Appl. No. 10/605,015
Amdt. dated October 21, 2005
Reply to Office action of August 02, 2005

Amendments to the Drawing:

REMARKS/ARGUMENTS

Fig. 2 Prior art

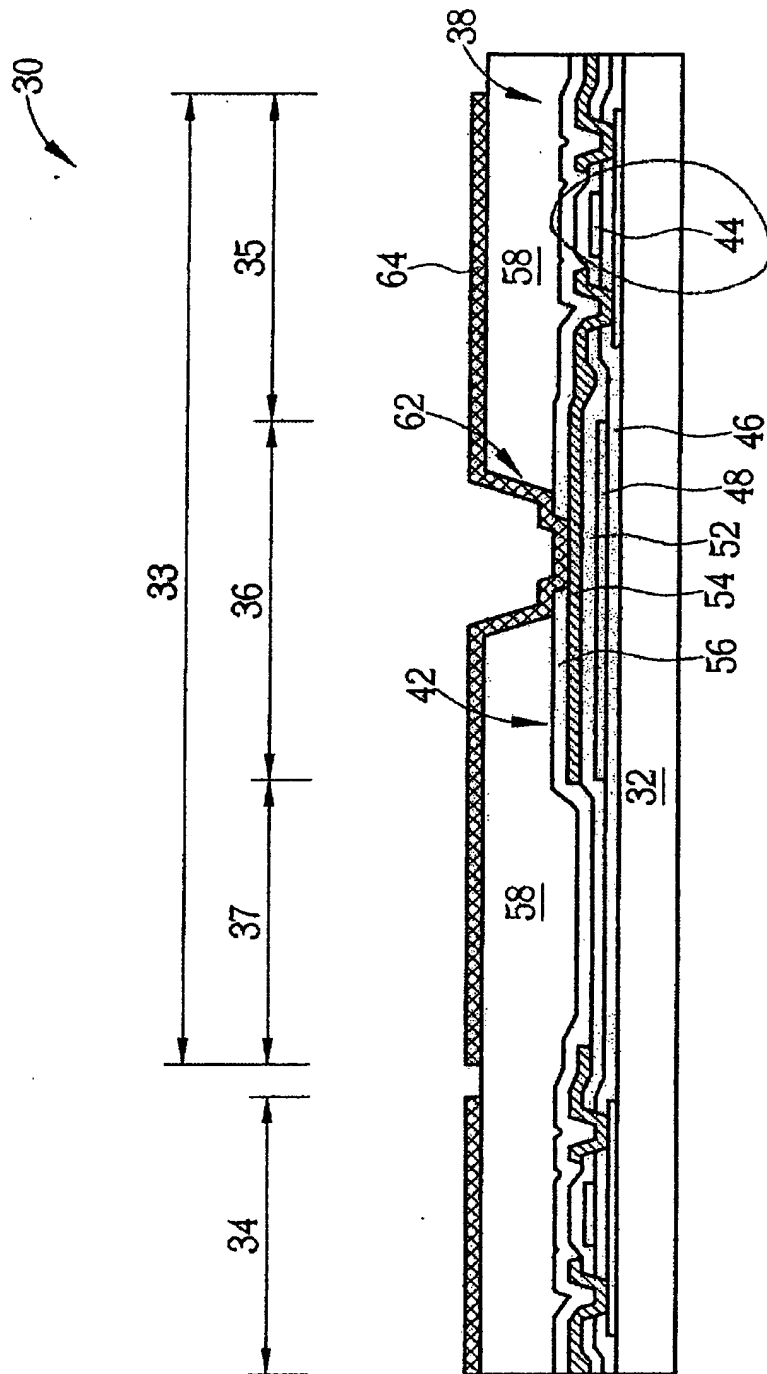
The gate 44 in Fig. 2 and the gate 114 in Fig. 3 are illustrated in wrong positions, and the amendments of drawings correct them.

Fig. 3

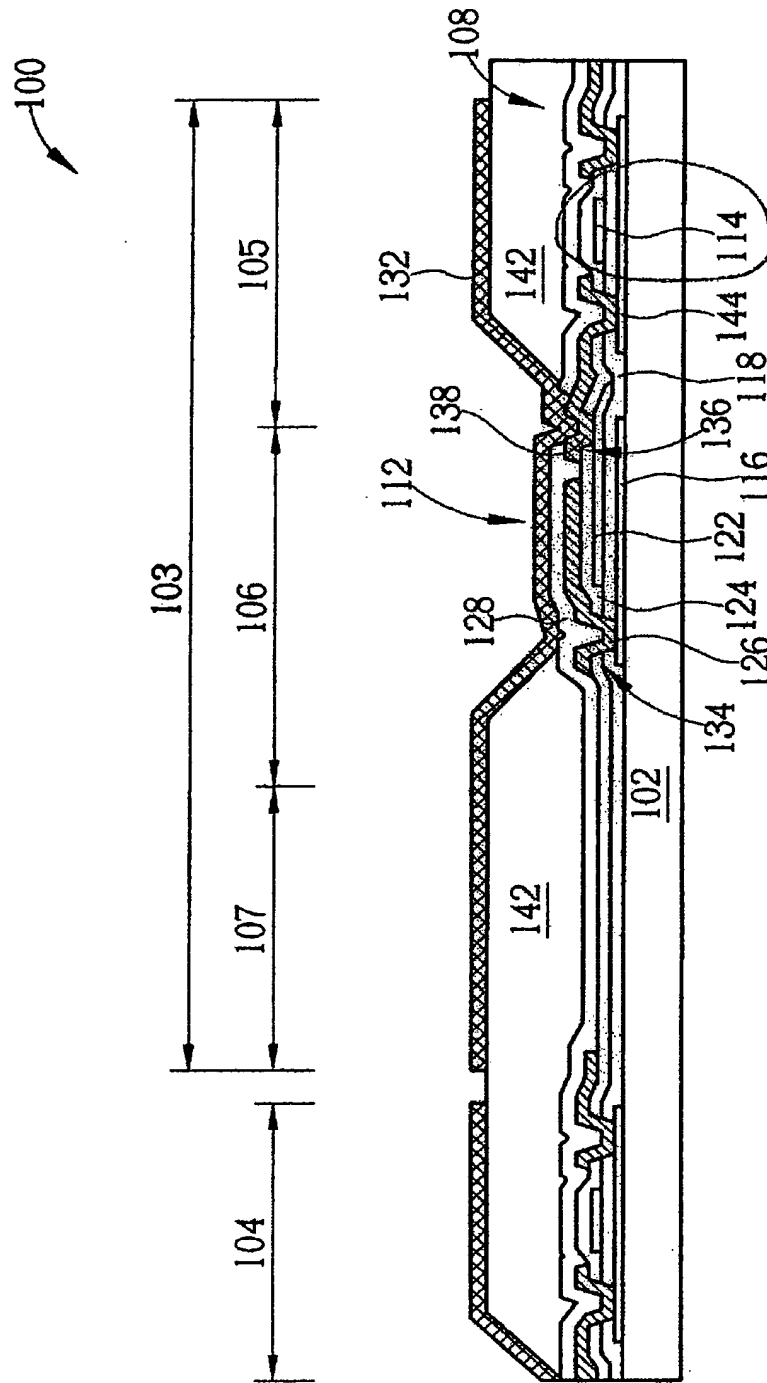
- 15 the fifth conductive layer 138 together with a scan line (not shown), electrically connected to the gate 114, are used to control the turn-on and turn-off of the thin film transistor 108." Besides, Fig. 3 supports the amendment of the first conductive layer disconnecting to a gate of the TFT in a display. Fig. 3 shows the first conductive layer 116 disconnects to the gate 114. No new matter is added in claim 1.

Claim 21 is added to mention: the gate and the capacitor are in the pixel array area. Claim 21 is supported by Fig. 3. Fig. 3 shows the gate 114 and the capacitor 112 are in the pixel array area 103. No new matter is added in claim 21.
